Project #: 15630.00

Re: Response to Peer Review Letter #1 – Traffic Review
NOVO Riverside Commons
292-294 Baker Avenue
Concord, Massachusetts

VHB has received and reviewed the comments outlined in the November 6, 2023 Traffic Peer Review Letter from GPI on the proposed NOVO Riverside Commons development at 292-294 Baker Avenue in Concord, Massachusetts. The comments and our responses are provided below.

AMBULANCE/DELIVERY SWEPTH PATHS

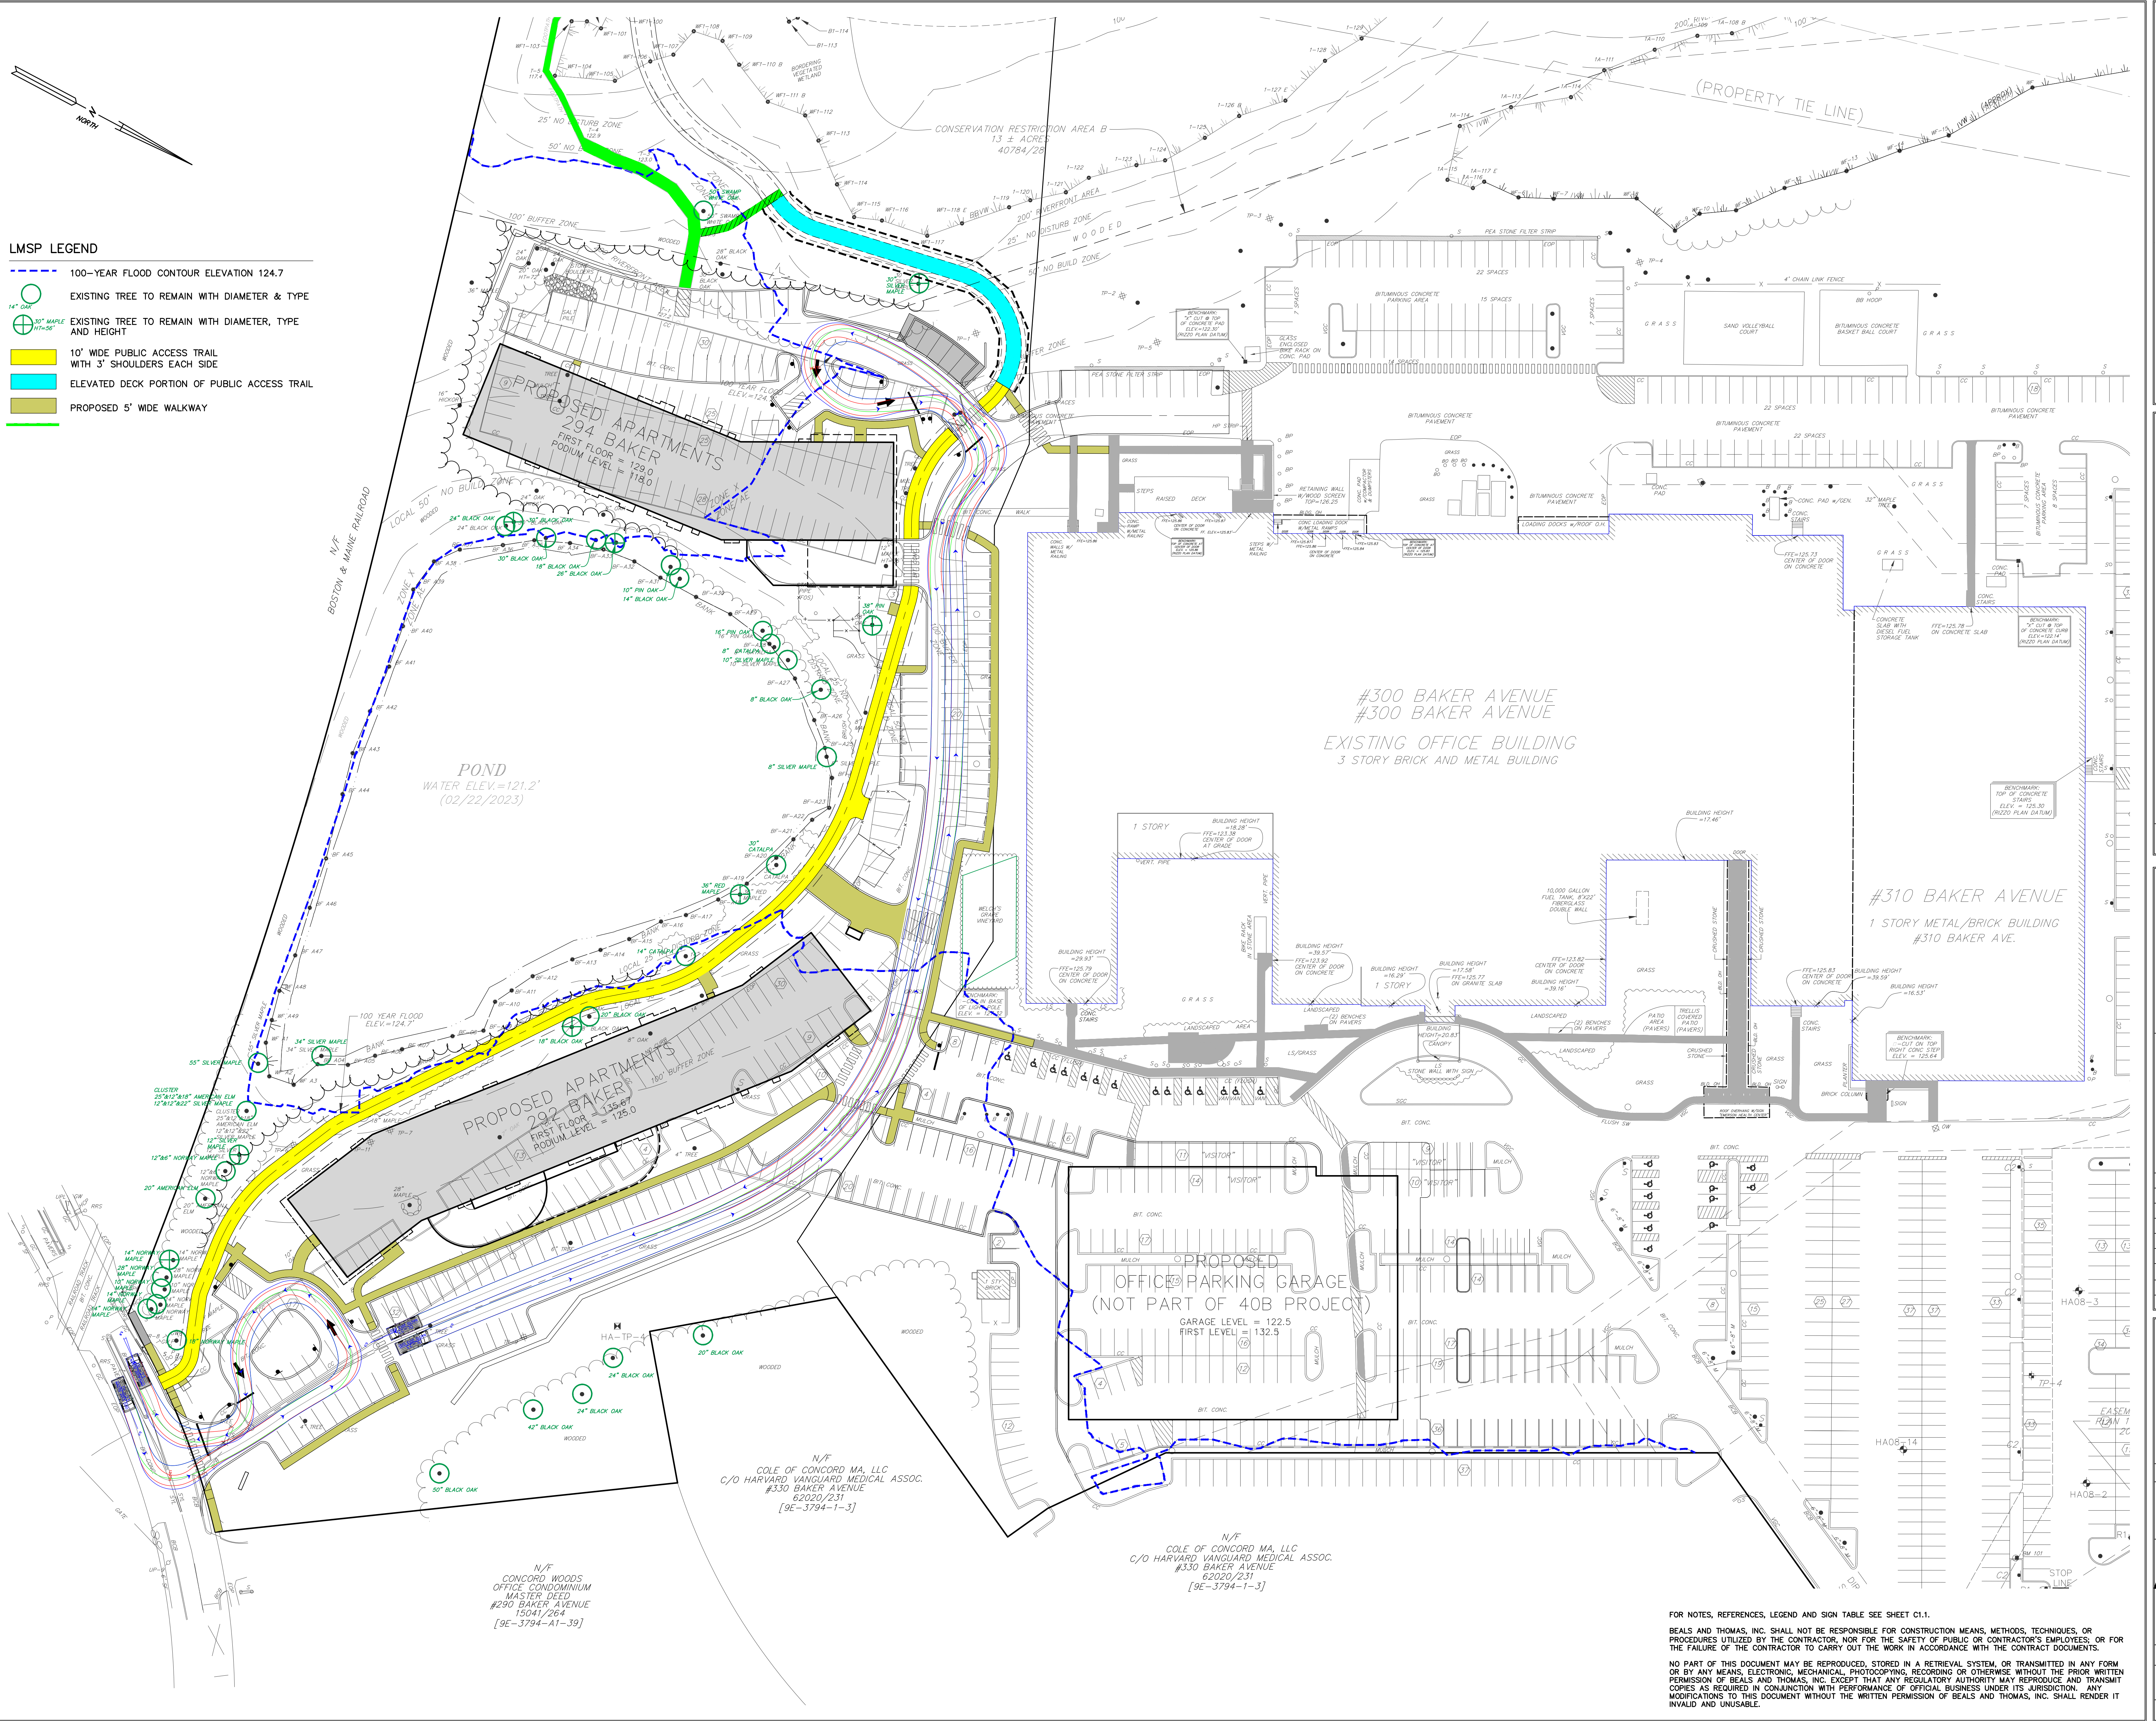
6. The handicap parking spaces are proposed to be located within the drop-off areas, which are only 20 feet wide. Although the hatched area between the handicap parking spaces will provide some additional maneuvering spaces, vehicles may have difficulty entering and exiting these spaces, particularly the spaces near #294 Baker Avenue. **The Applicant should provide vehicle turning path diagrams to depict the path of vehicles entering and exiting the handicap spaces.**

7. **The Applicant should provide vehicle turning path diagrams depicting the access and circulation of emergency vehicles, delivery vehicles, and trash removal vehicles for the site.**

Response: We have prepared vehicle turning path diagrams and have attached as an exhibit to this document.

Response: We have prepared vehicle turning path diagrams for emergency vehicles, delivery vehicles, and trash removal vehicles, and have included as exhibits to this document.

CONCORD FIRE LADDER 1 SWEPHTH PATHS

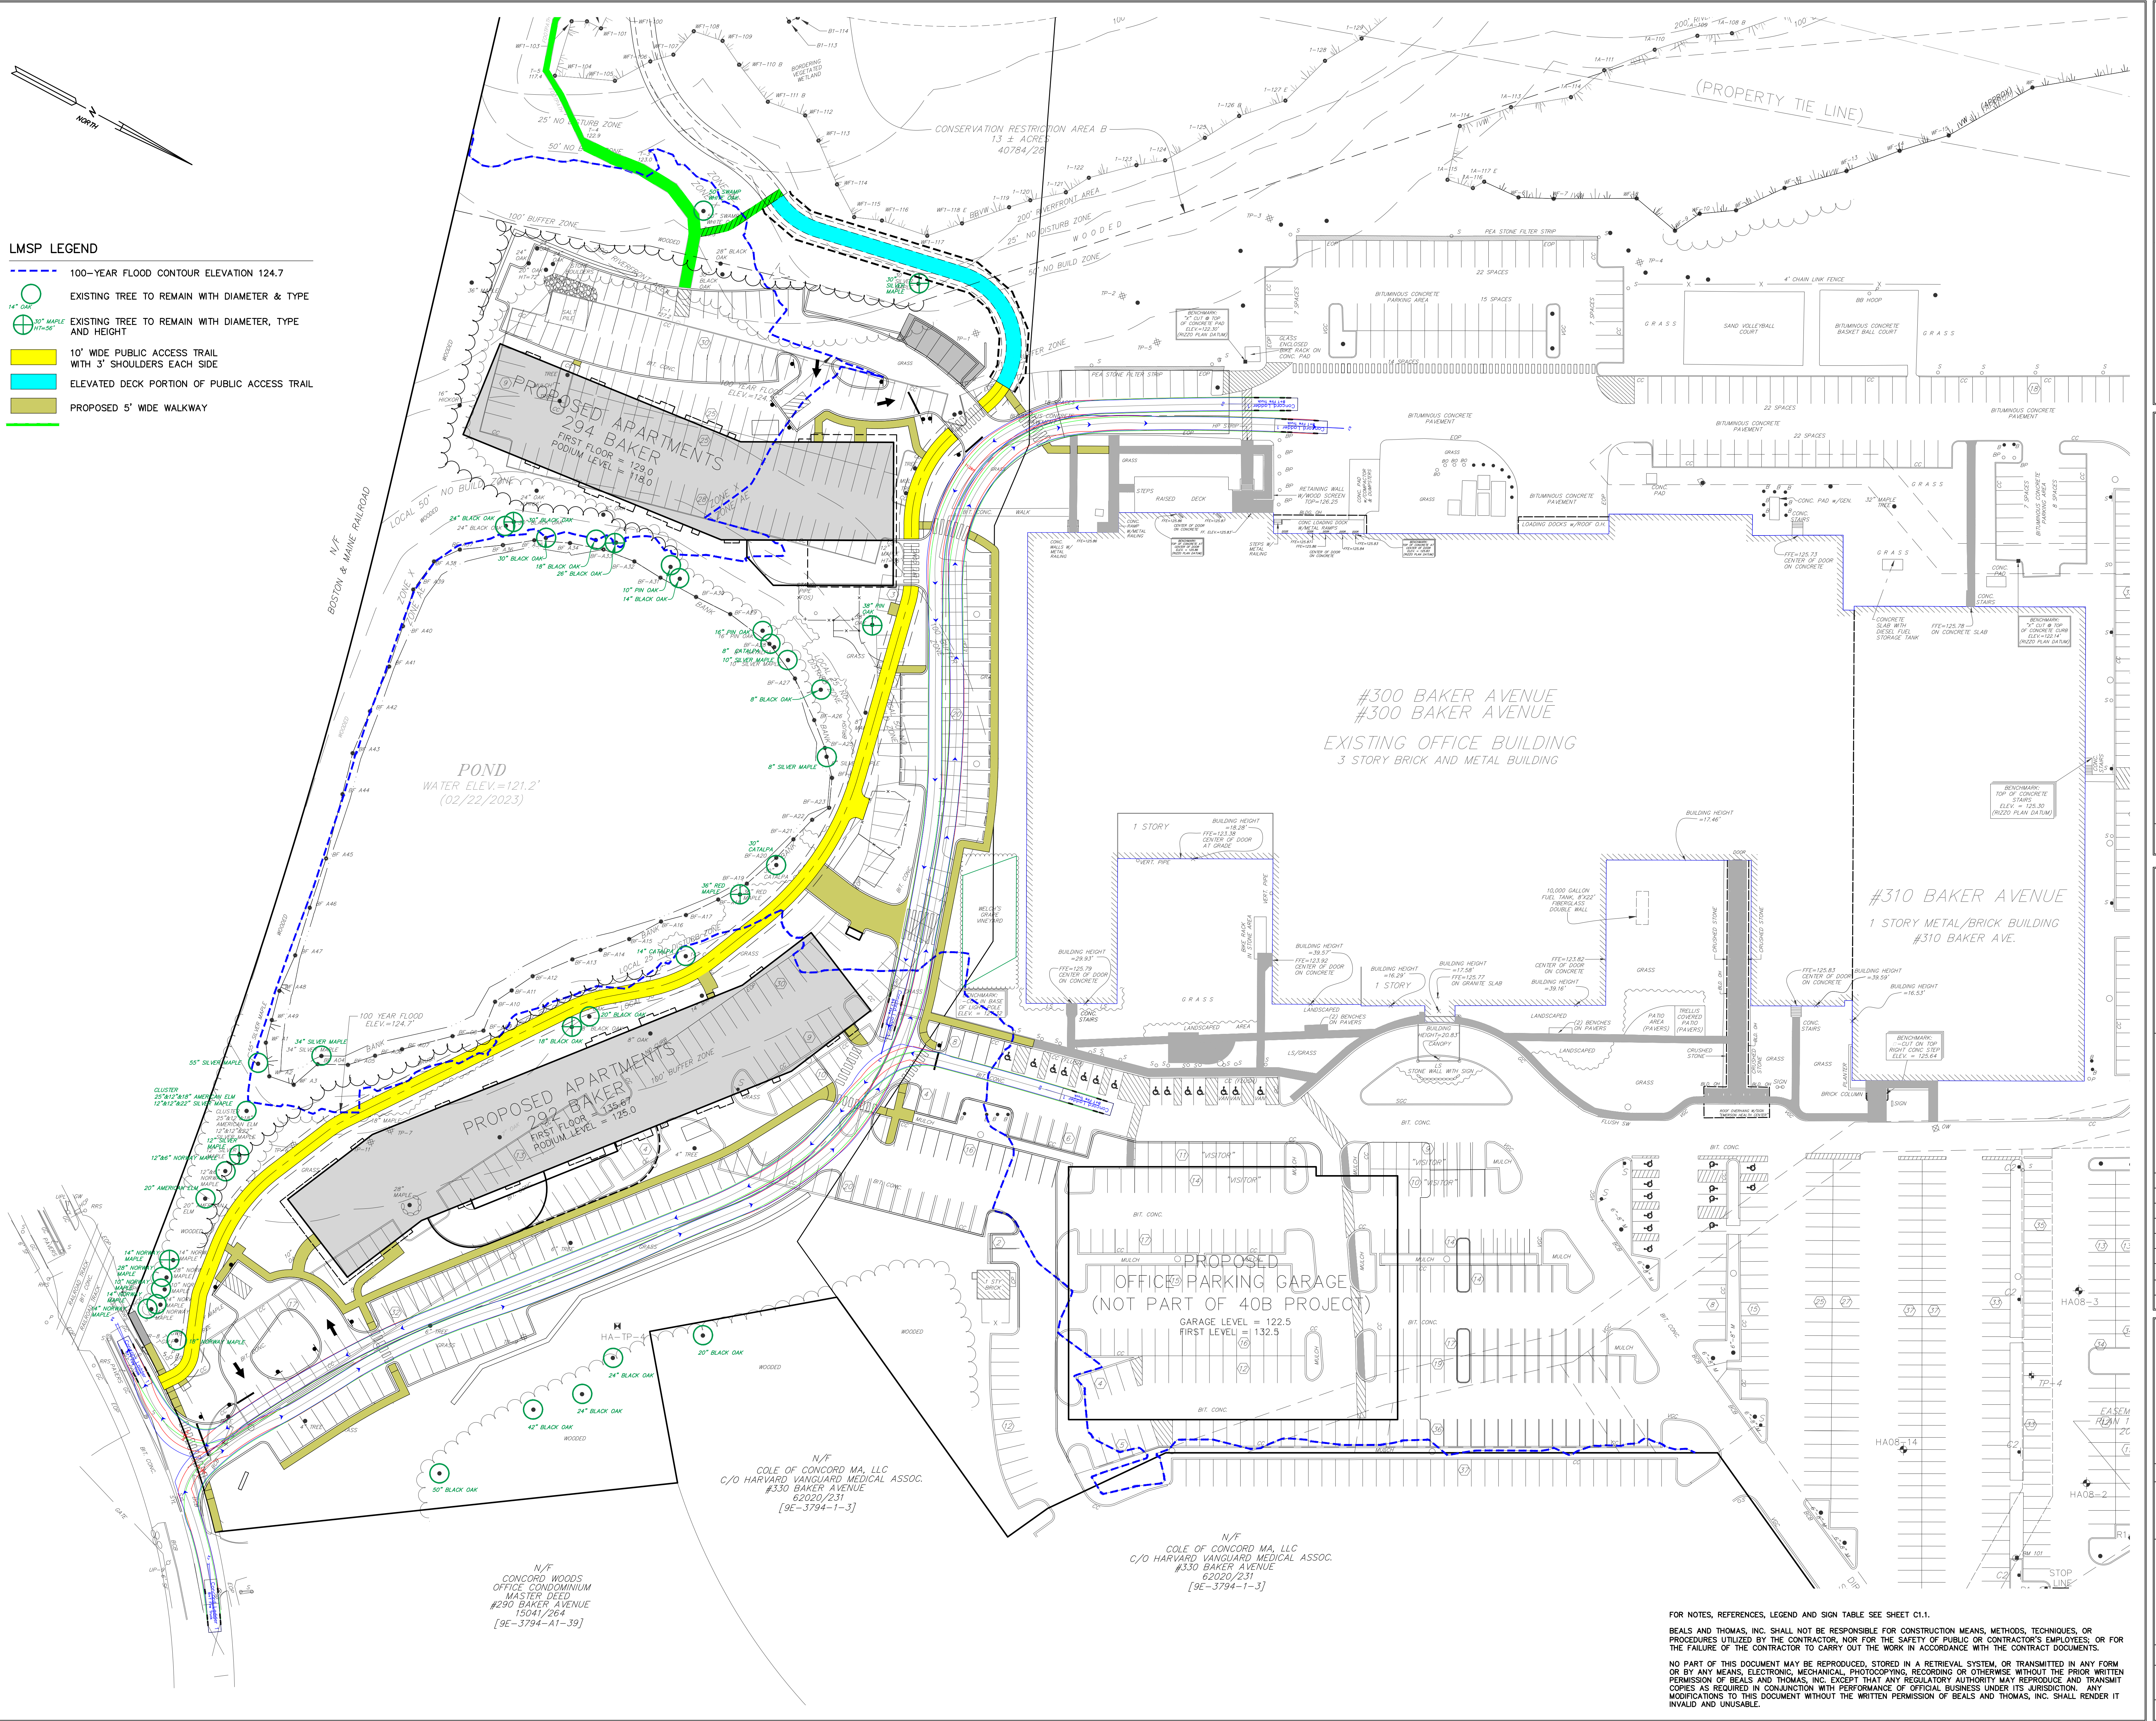
8. It appears that the Applicant is proposing to utilize the proposed public access trail for fire apparatus access to the buildings. **The Applicant should confirm that this is the case and demonstrate the ability of a fire apparatus to efficiently access and egress the public access trail.**

Response: The public access trail is only intended to be used by a pickup sized emergency access vehicle based on preliminary conversations with the Fire Department. The Fire Lane can be accessed directly from Baker Avenue and the proposed Fire Lane northwest of 292 Baker Avenue.
